SEWAGE DISPOSAL TESTING

MARYLAND STATE DEPARTMENT OF HEALTH

PROPERTY OWNER John L. Egerton

ROAD AND DESCRIPTION Hipsley ^{Mill} Road and Annapolis Rock Road. - at intersection

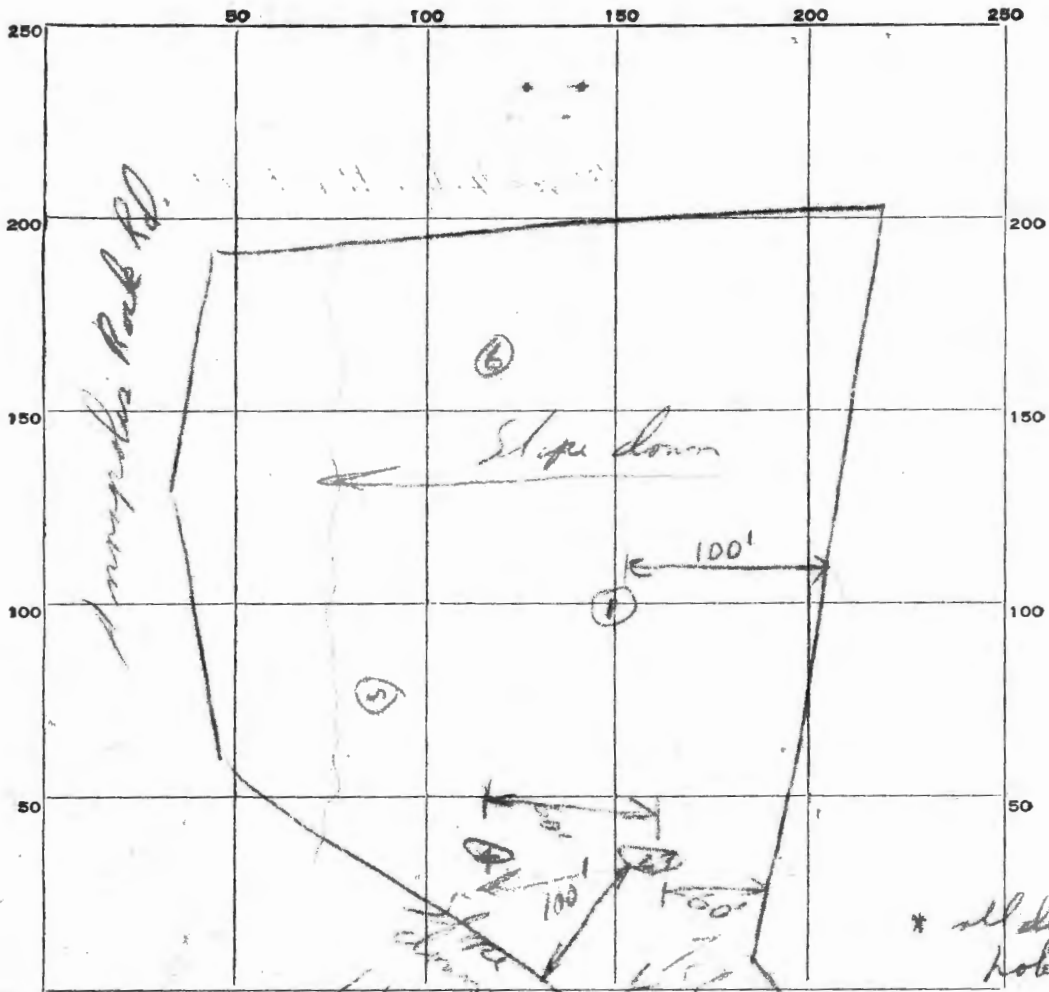
REASONS FOR REJECTION OR HOLDING *Low yield - roof and clay on high party*
lot unsuitable for construction

SOIL AUGER FINDING: Holes # 2 & 3 - Red Clay and rock all way down - extremely hard to dig

REMARKS: Poor soil, pressure. - Needs further tests - K.F.

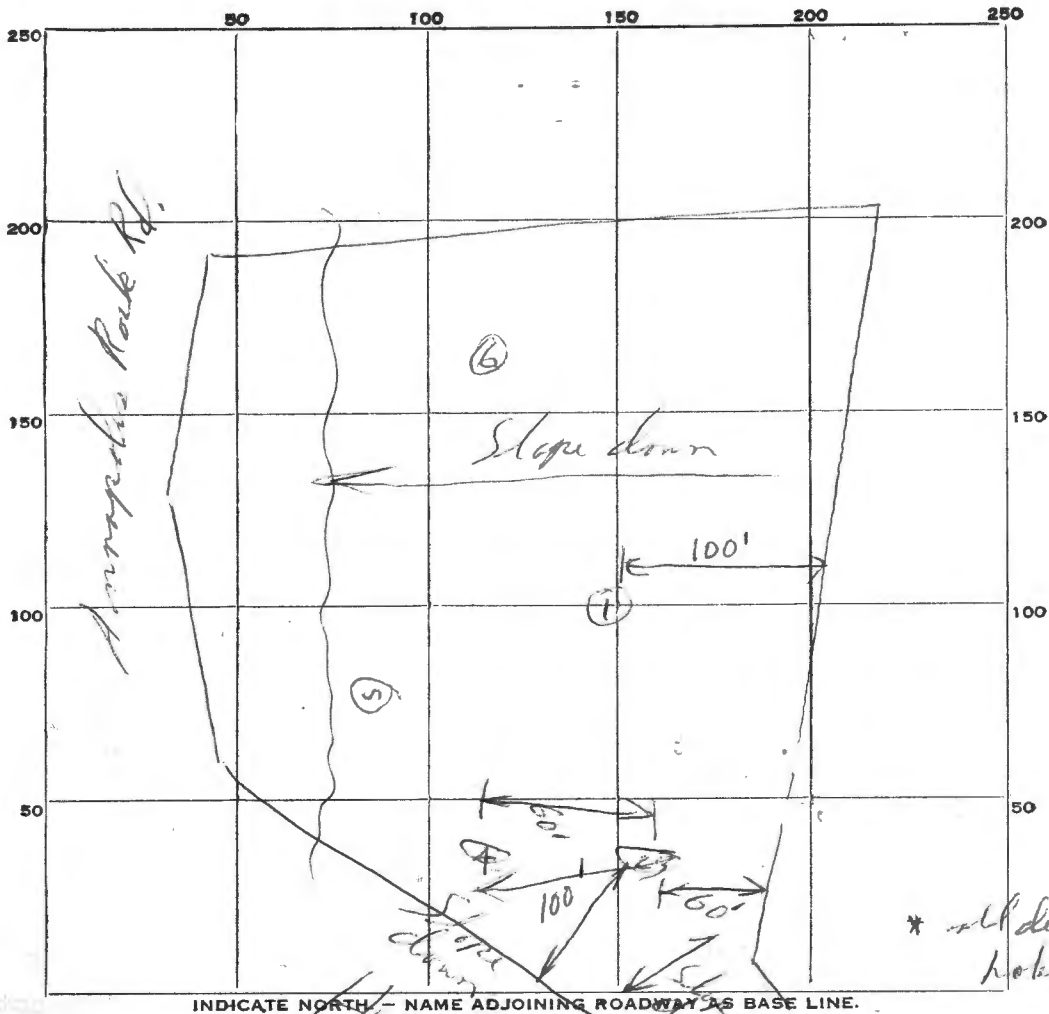
REASONS FOR REJECTION OR HOLDING *Soil - rock and clay on high part of lot - water at 2 ft on lower part - etc.*

SOIL AUGER FINDING Holes # 2 & 3 Red Clay and rock all way down - extremely hard to dig

REMARKS Poor soil, no pore. - Needs further tests - R.D.F.
